ADDENDUM NO. 2

TRACK & FIELD IMPROVEMENTS - INC 1

Adolfo Camarillo High School

November 4, 2019

AD2-C12

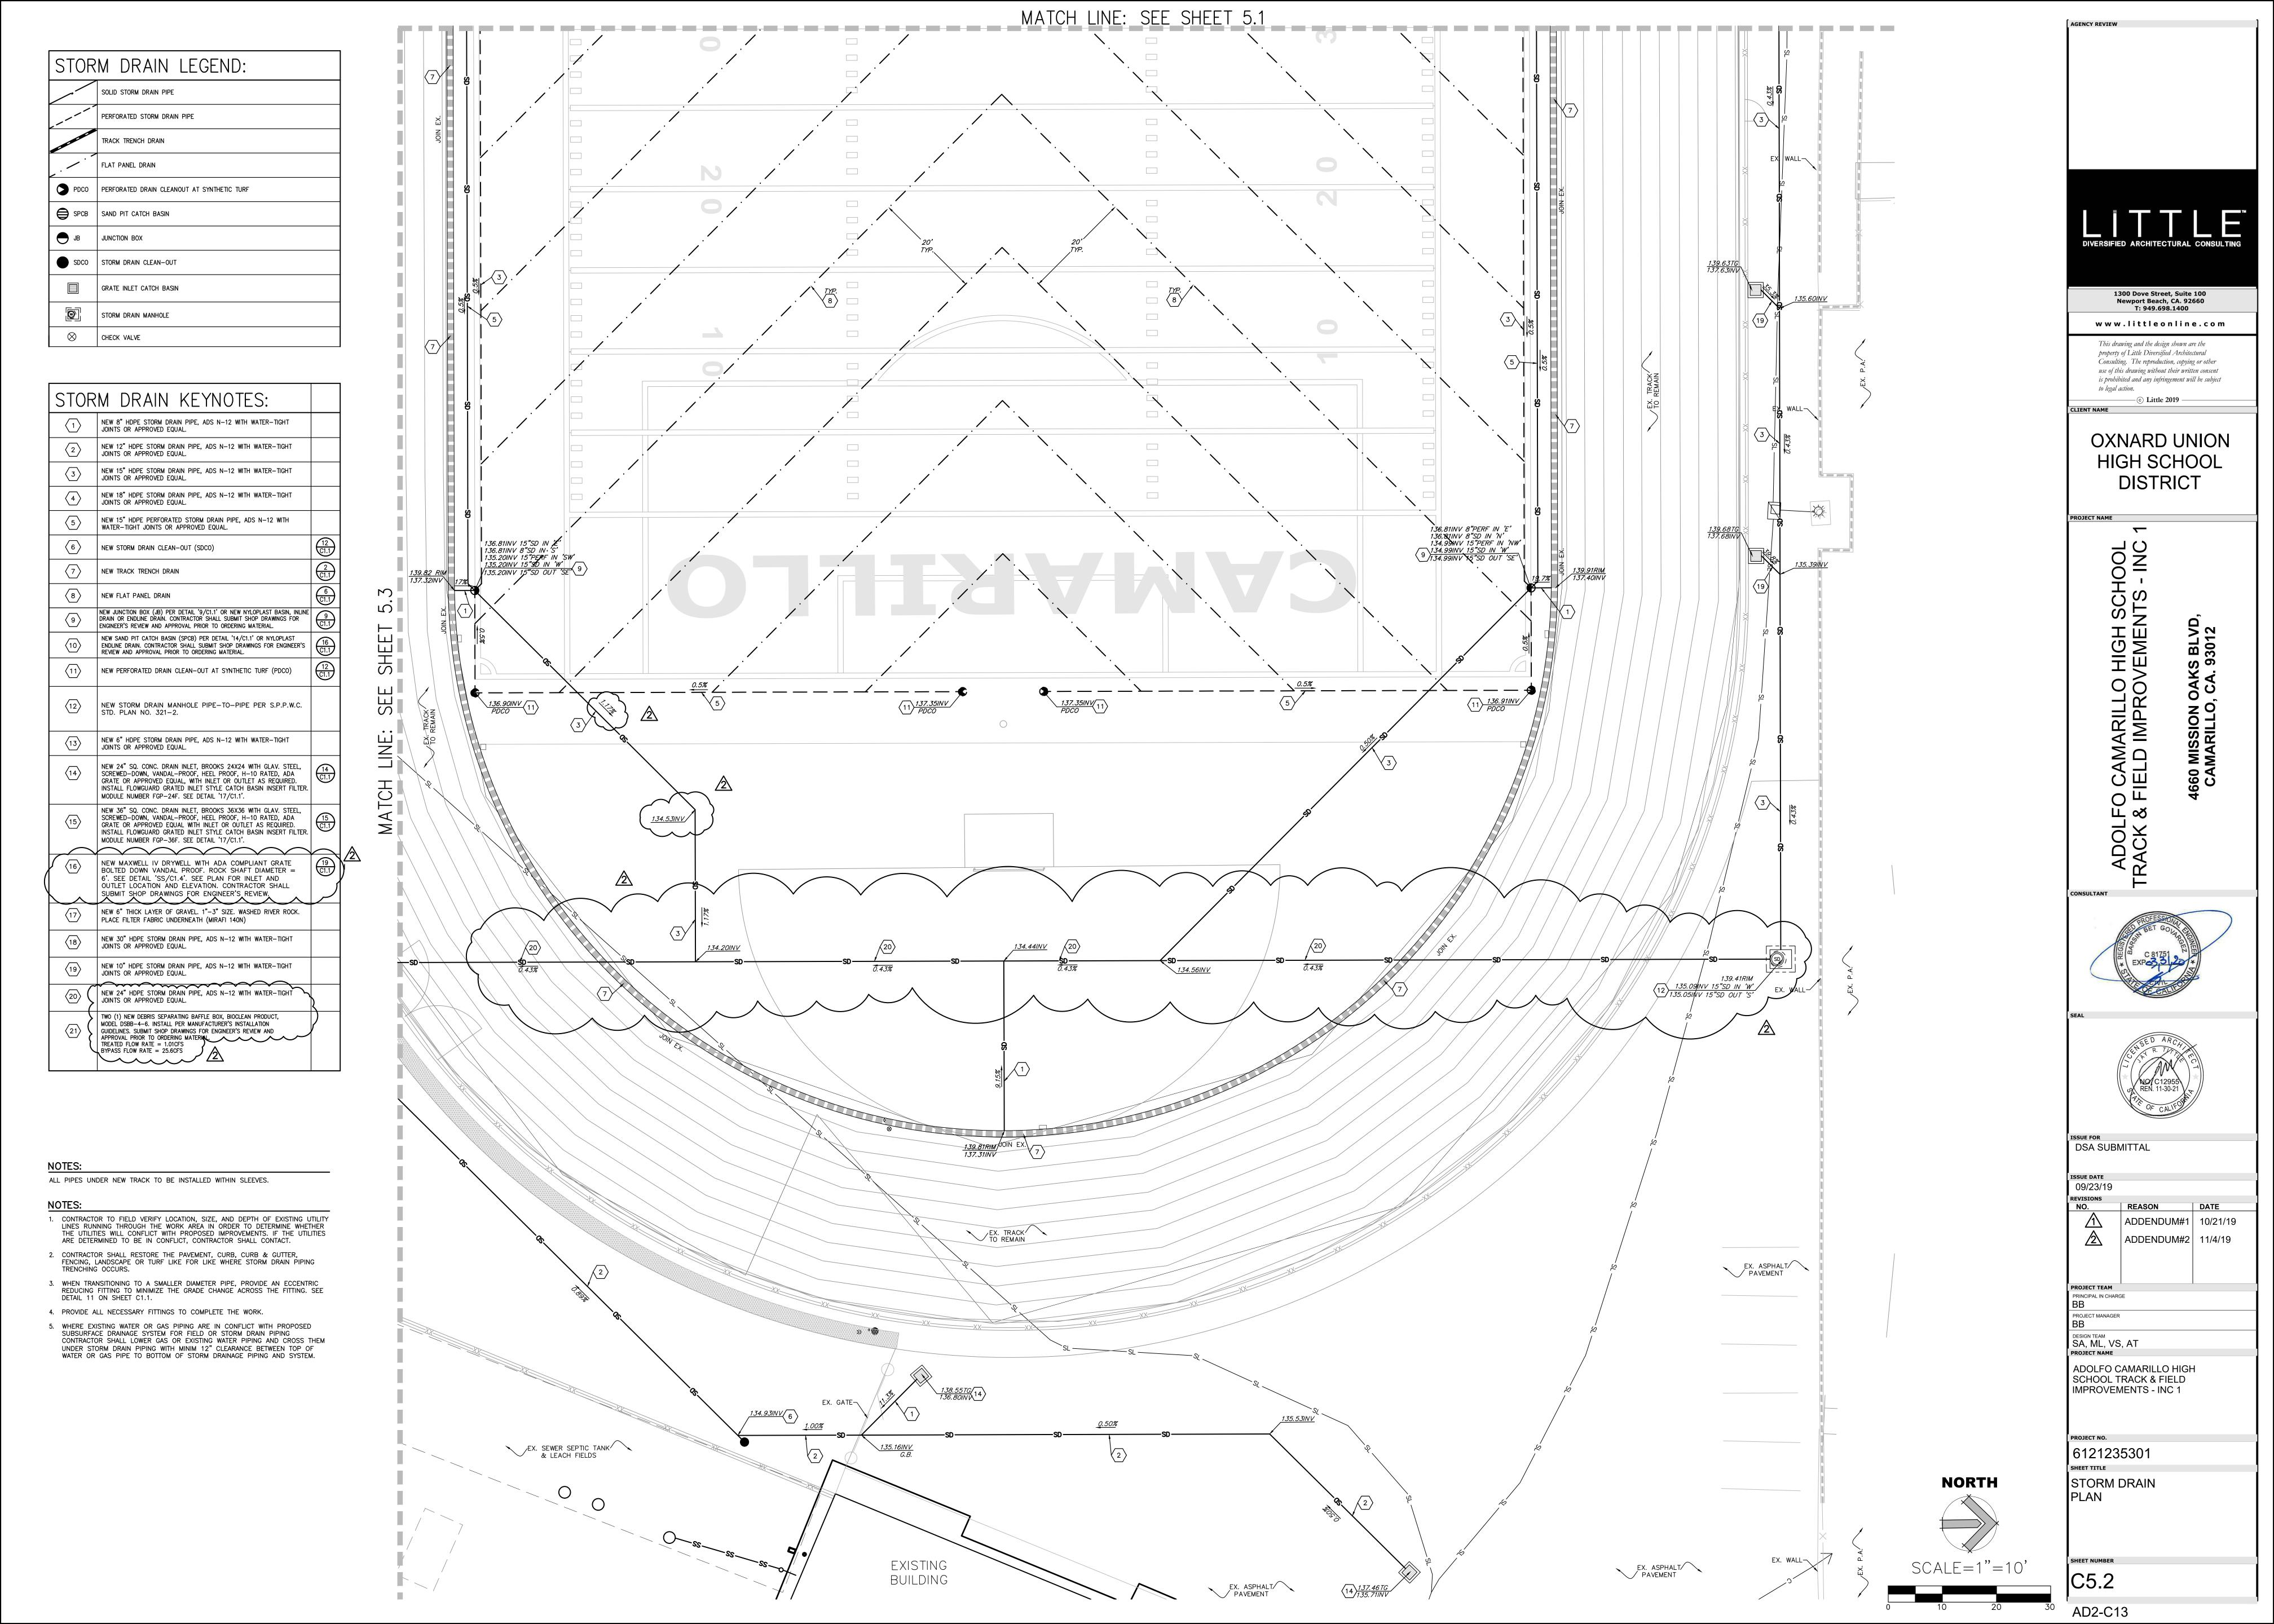
- **3.1.1.12.** Drawing C-5.1/AD1-C4: Revise currently issued Drawing per AD2-C12.
 - 3.1.1.13. Drawing C-5.2/AD1-C5: Replace with Drawing AD2-C13.
 - **3.1.1.14.** Drawing C-5.3/AD1-C6: Replace with Drawing AD2-C14.

E-000

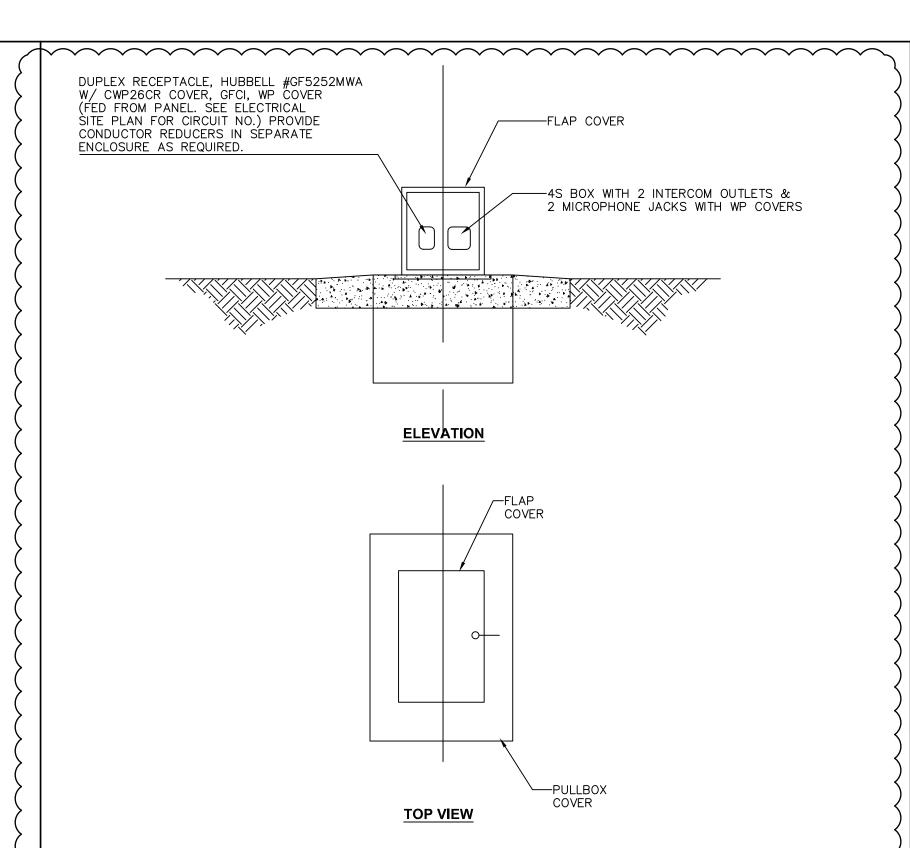
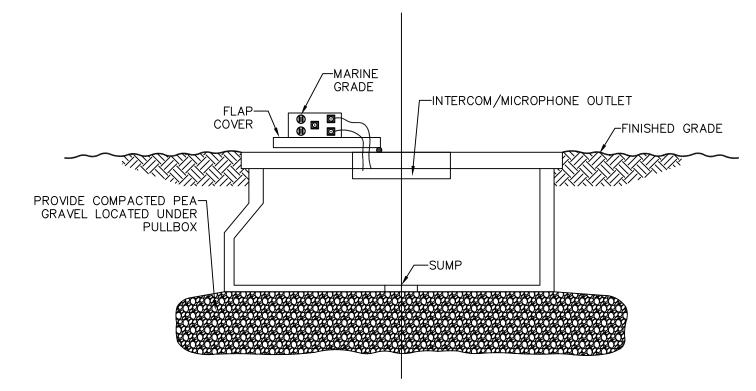
- **3.3.2.1.2.** For box sizes refer to sheet AD2-E1 and AD2-E3 for quantity & size of conduit connected to each junction box, to determine box size at each location. Contractor to refer to 'as-built plans' AD2-E4 & AD2-E5 for box sizes, including P1, P2, P4 & P5.
